March 28, 1994
ST-HL-AE-4751
File No.: G9.18
G25
10CFR50 App A

South Texas Project
Units 1 and 2
Docket Nos. STN 50-498; STN 50-499
Additional Information Regarding Performance of
Main Cooling Reservoir and Essential Cooling Pond During and
After Filling to Elevation + 45 Feet (TAC Nos. M86279 and M86280)

RESPONSE TO
NRC REQUEST FOR ADDITIONAL INFORMATION
LETTER DATED FEBRUARY 10, 1994

PROFILE 3
EMBANKMENT STATION 20+00
SOUTH TEXAS PROJECT
14926-001

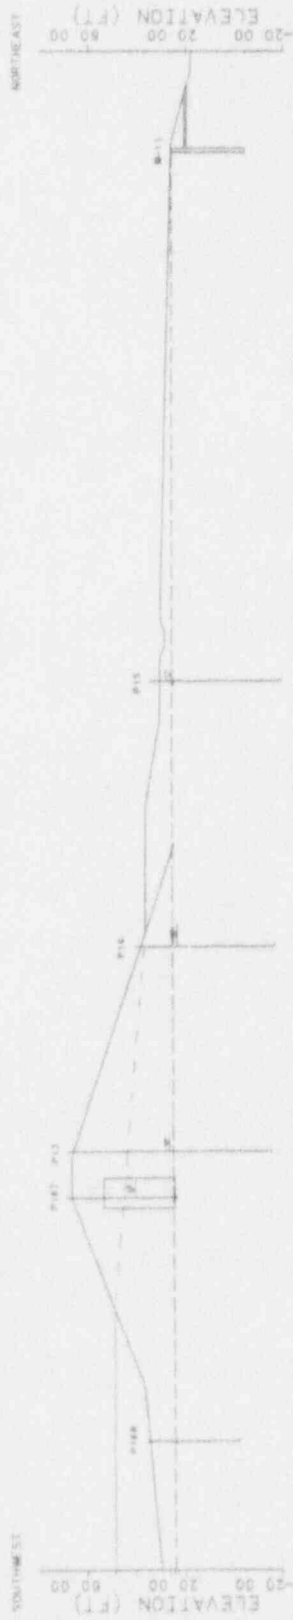
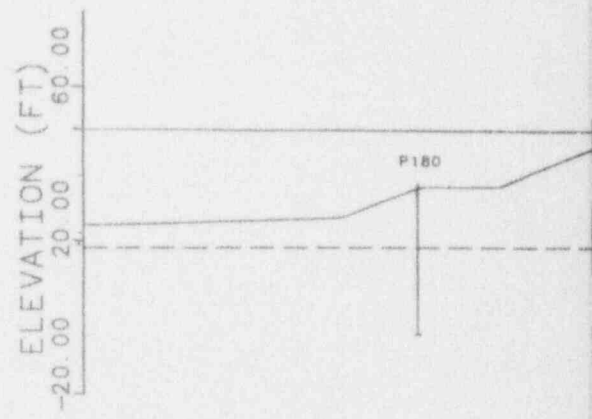
1. Perform necessary investigations to determine if the high water table in the Main Cooling Reservoir (MCR) embankment sand core is a temporary phenomenon. If it is not a temporary phenomenon, plot the phreatic surface across the embankment section at a few representative locations and compare them with that assumed in the original embankment stability analysis, and determine the factor of safety of the embankment against failure for the high water table condition.
2. Determine the cause for the high seepage gradients across three cross sections of the MCR embankment. Evaluate the effects of such high gradients on the stability of the embankment and take suitable measures to reduce the high seepage gradients to acceptable levels.

Attached profiles 3, 19, and 31 are cross sections of the MCR embankment at locations with relatively high water tables in the sand core. The water table in the sand core has been remarkably stable since completion of construction.

The original embankment stability analysis assumed a phreatic surface extending from the maximum design reservoir elevation of +49 feet to the top of the +35 foot berm on the down-stream side of the embankment ("Evaluation of Strength Parameters and Stability, Main Cooling Reservoir Embankment", Harza Engineering Co., September, 1984, ST-XH-YB-013). As shown on the Profiles, the assumed phreatic surface for the stability analysis is conservatively above the water level in the sand core.

Factors of safety based on assumed piezometric levels are presented on attached table 2 from the above referenced report, ST-HX-YB-060. Although the phreatic surface in the sand core is higher than expected, it remains below the design parameters selected.
